# Certificate of Appropriateness

**Property** 2581 N. DOWNER AV. Downer Avenue Historic District  
**Description of work** Install black entry canopy in front of storefront. Replace existing doors and transoms to match with product shown below. Repair mirror frames at top corners of storefront and replace mirror glass. Replace existing metal grille in entry recess and install second matching grille to cover a hole opposite the existing grille. Install signage and lighting above storefront. Remove existing neon sign. Paint various non-masonry surfaces. All details to be as shown below.  
**Date issued** 2/24/2017 PTS ID 114214 COA: signs, canopy, and decorative grilles

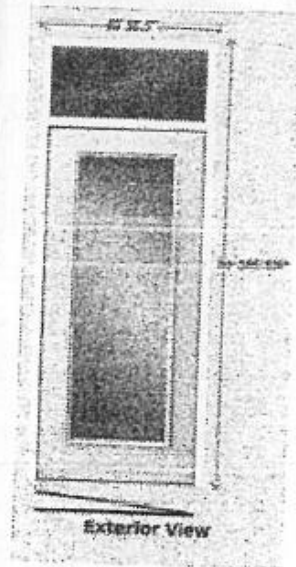
Replacement door as proposed. Handles from existing doors shall be reused and exterior of replacement doors, trim, and jamb shall be painted. Full lite and transom glass to be clear. Low-E coating is permitted if clear. Must be placed in existing opening.
